SUBJECT: PURDUE UNIVERSITY - REQUEST FOR ADDITIONAL INFORMATION REGARDING  
THE PURDUE UNIVERSITY REACTOR LICENSE RENEWAL (TAC NO. ME 1594),  
RESPONSES TO RAIs (ML103400115 and ML103400250)

**REQUESTED ADDITIONAL INFORMATION IN RESPONSE TO RAIs**

**REGARDING THE PURDUE UNIVERSITY REACTOR LICENSE RENEWAL (TAC NO. ME 1594)**

Figure 1: Weekly make-up water usage for PUR-1.

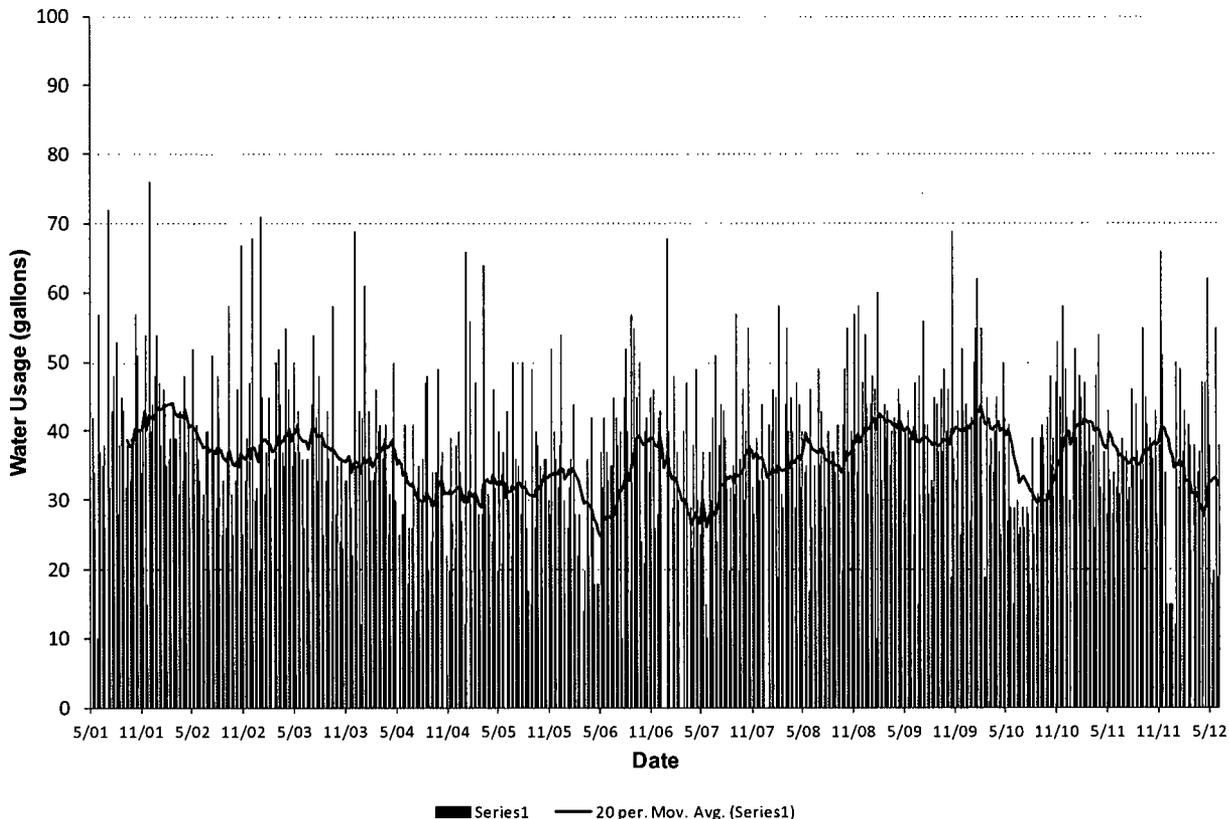
**52. SAR Section 5.5 describes automatic pool water level control. Please describe how you would determine if the amount of make-up water to the reactor pool was excessive and indicative of a pool leak.**

- a. **Section 5 of the SAR does not describe reactor pool level monitoring. Please discuss how reactor pool level is monitored, and if a leak develops in the reactor pool cooling system during off-hours, how it would be mitigated when approximately up to four feet of pool water could leak out?**

- c. **Please provide an estimate of the minimum detectable amount of leakage and an estimate of how long such a leak could exist before detection; any trends associated with the required make up water, and the physical means with which PUR-1 can detect small releases from the pool directly to the environment.**

The automatic pool water level control is only activated when needed to replace evaporated coolant inventory, and the automation is solely to prevent overflow of the pool. Operations staff activate the system, and track the amount of water used each time in a log book. Data exists for facility water usage back to

about 1974. In looking at the last 15 years, the average weekly water usage has been  $36.8 \pm 12$  gallons. The data are presented in Figure 1. Weekly usage that exceeds the average value plus three standard deviations could indicate a leak.

Pool level is monitored by comparison of the pool level to a ruler at the top of the pool, and is observed at least once a week by reactor staff members. Make-up water usage is tracked in a log book on the console. In looking at the last 15 years, the average weekly water usage has been  $36.8 \pm 12$  gallons. The data are presented in Figure 1. Weekly usage that exceeds the average value plus three standard deviations could indicate a leak.
